**VALUE ENGINEERING STUDY
OF
RECONSTRUCTION OF I-64/
KY 180 INTERCHANGE
Item Number: 9-60.00**

**Boyd County, Kentucky
October 17-21, 2005**

**Prepared by:
VENTRY ENGINEERING, L.L.C.**

**In Association With:
KENTUCKY TRANSPORTATION CABINET**

KY 180 CROSS-SECTIONS
 STA. 24+50 TO STA. 24+70

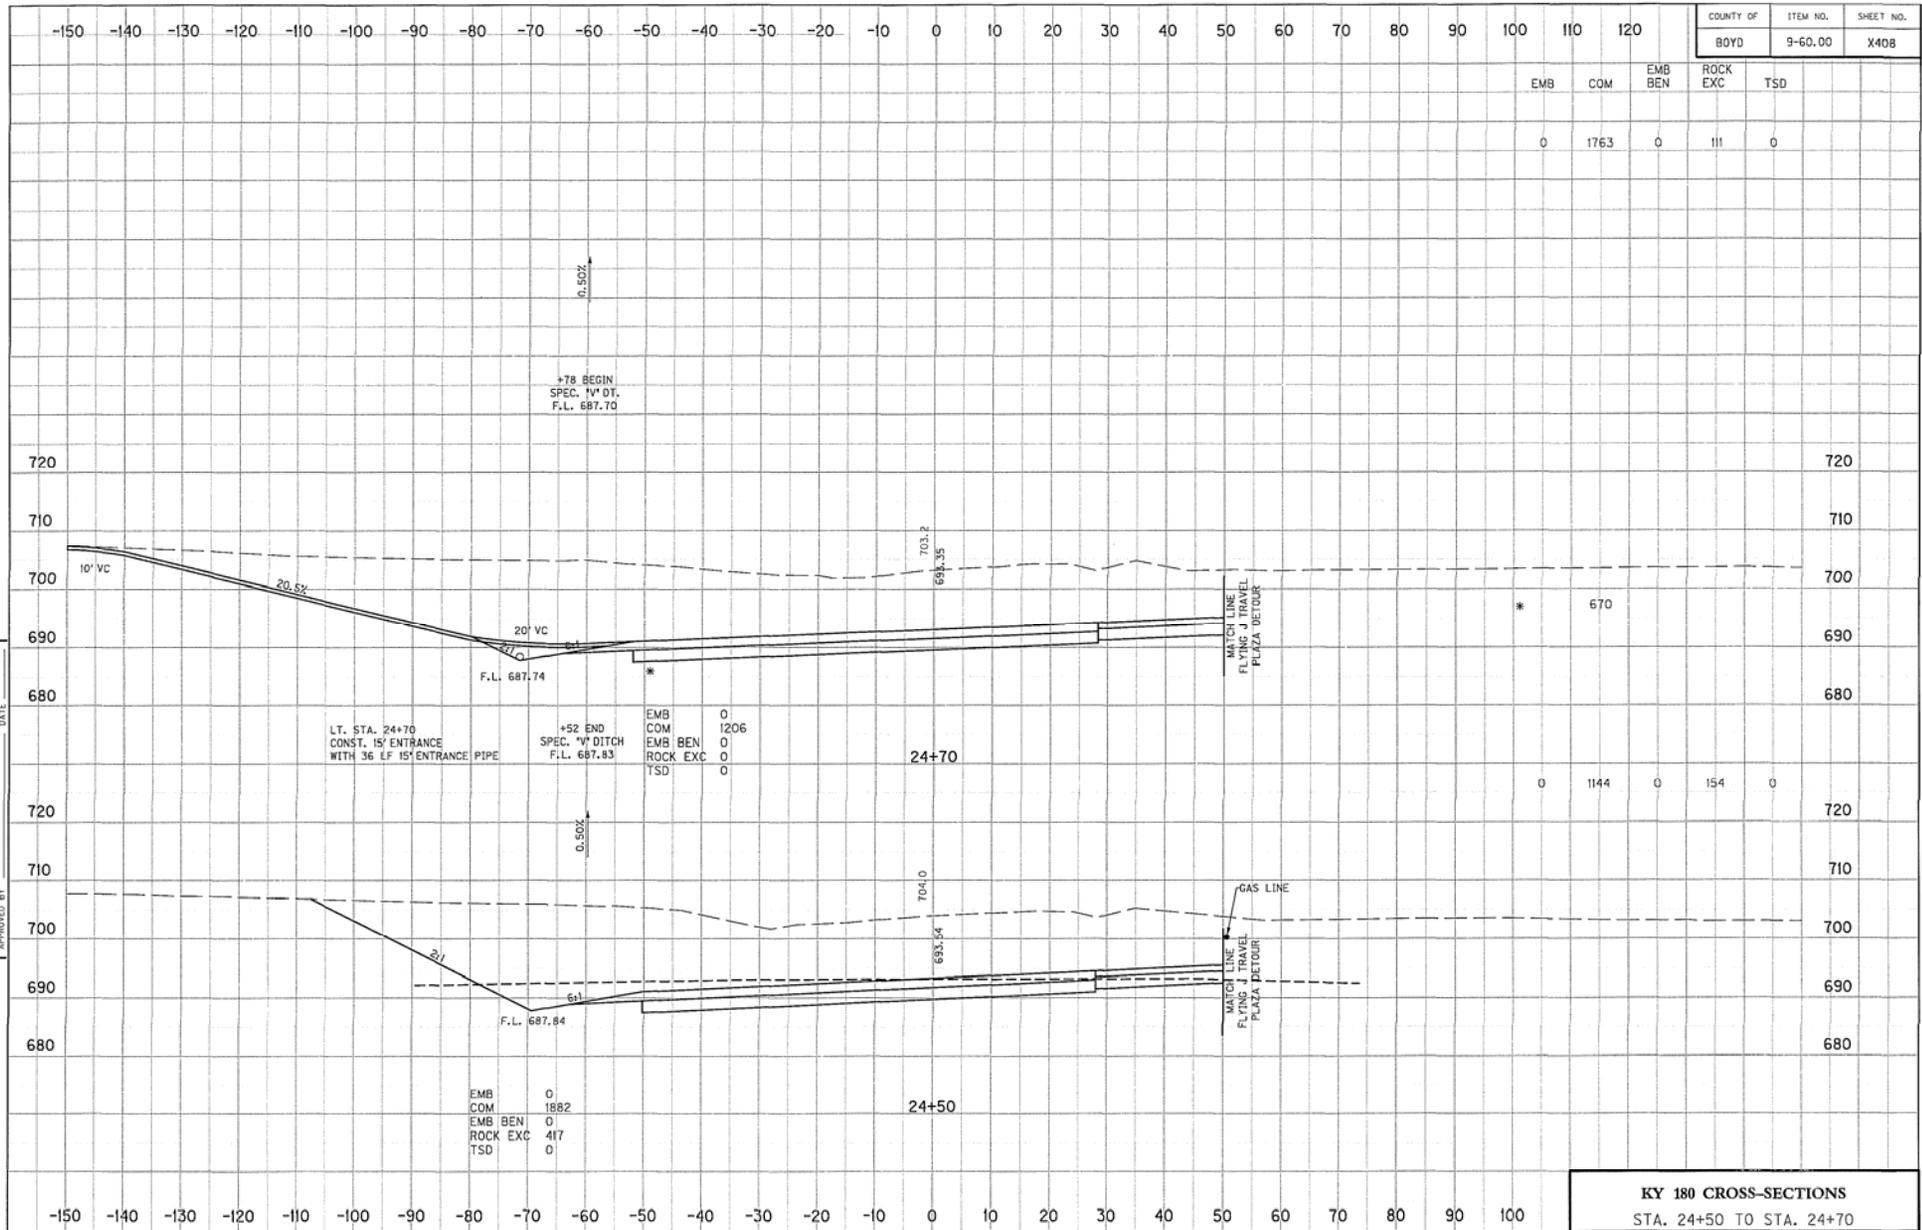
This Value Engineering alternative modifies the profile grade of KY 180 from station 15+00 to station 40+00. The alternative profile grade configuration consists of a grade of +7.2% ending at station 22+00 to a -4.0% grade ending at 34+00 to a + 1.0% grade which ties into a -3.38% grade.

The development of this alternative resulted in improvements to the profile grades of the entrance to the Flying J (from +6.36% to +5.0% and included increasing the length of the vertical sag curve on the entrance near KY 180), Field Avenue (from +11.8% to a constant +6.6%), Flying J detour (from +3.9% to +3.0%) and several other entrance drives. By modifying the entrance grade to the Flying J we were able to reduce the size of the proposed gravity retaining wall. Also, the gravity retaining wall on KY 180 at 26+00 was able to be reduced due to raising the KY 180 profile grade.

With the modification of the KY 180 profile grade the cut in the first crest curve was reduced by 5 ft. which eliminated approximately 25,000 cy of excavation. An additional benefit resulting from the grade change is in the sag vertical curve at station 34+00 which increased the embankment requirement allowing for additional use of excess excavation on this project.

RAMP A PLAN
STA 10+00 TO STA 20+00

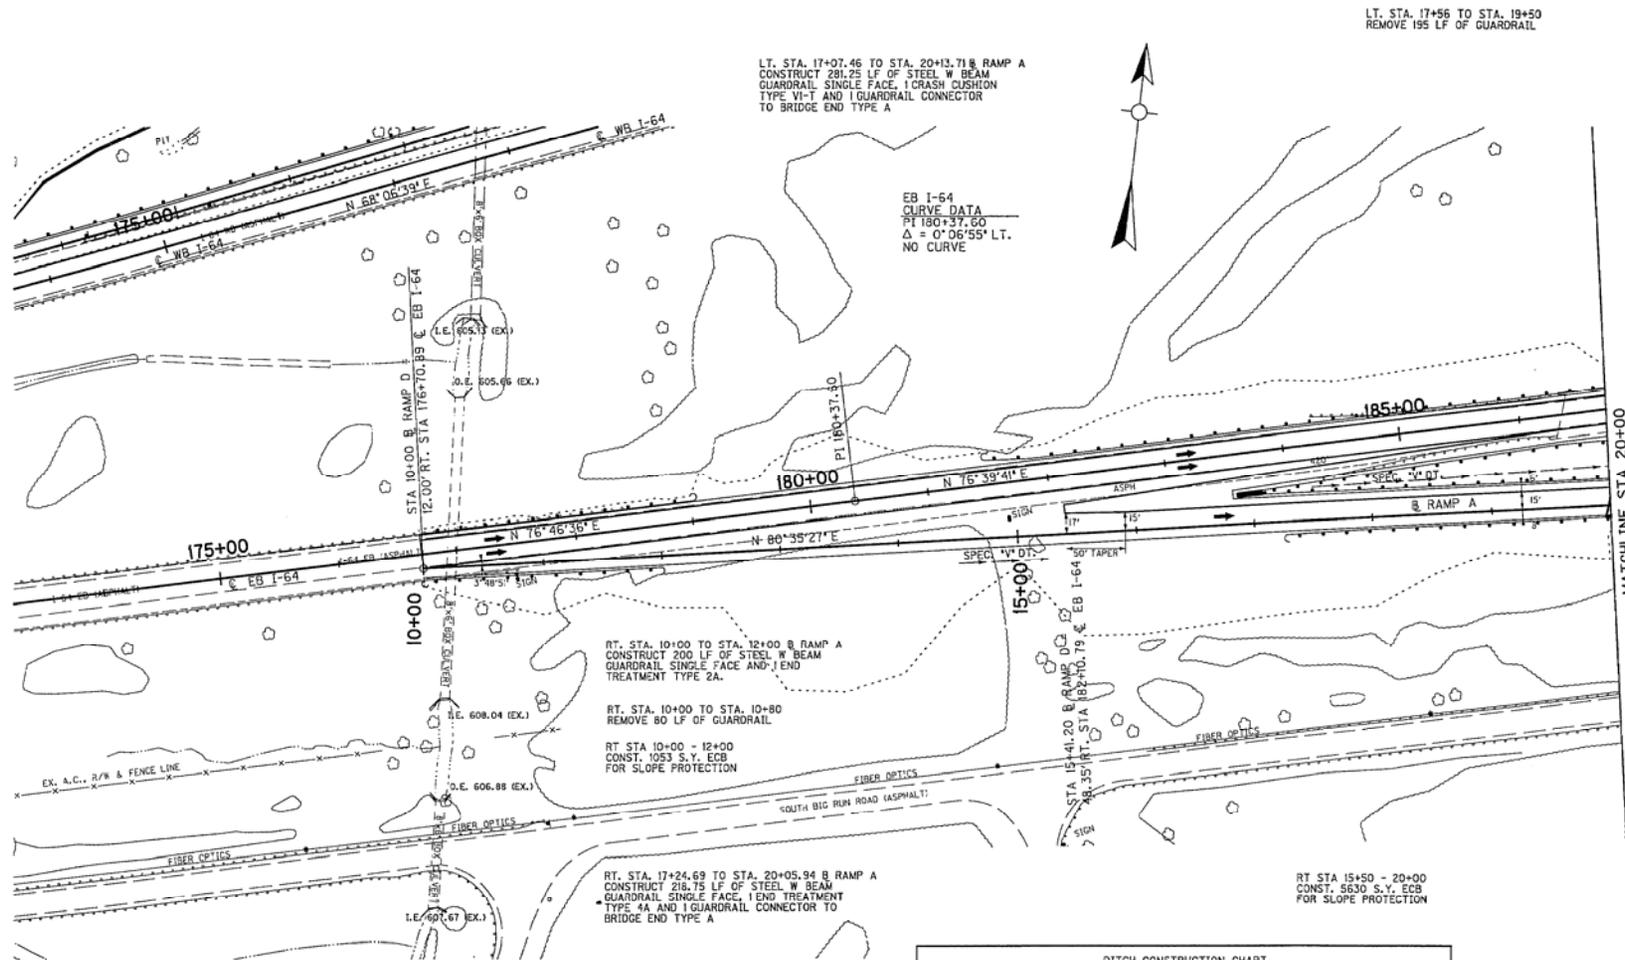
The As Proposed west-side ramps for the I-64/KY180 interchange are tapered ramps aligned in accordance with Kentucky’s common practices interchange configuration in a rural area. The ramp alignments are separated from the mainline by 80 ft. at the East Fork Little Sandy River, thereby requiring two separate river crossing structures. The ramp river crossing structures are 30 ft. wide and 300 ft. long each.

The VE team recommends that the intersection of the A and D ramps with KY180 be modified to provide a better operating intersection in closer conformity with Kentucky's desired intersection criteria. The VE team believes that desirable intersection criteria should control over open road criteria at a major signalized intersection.
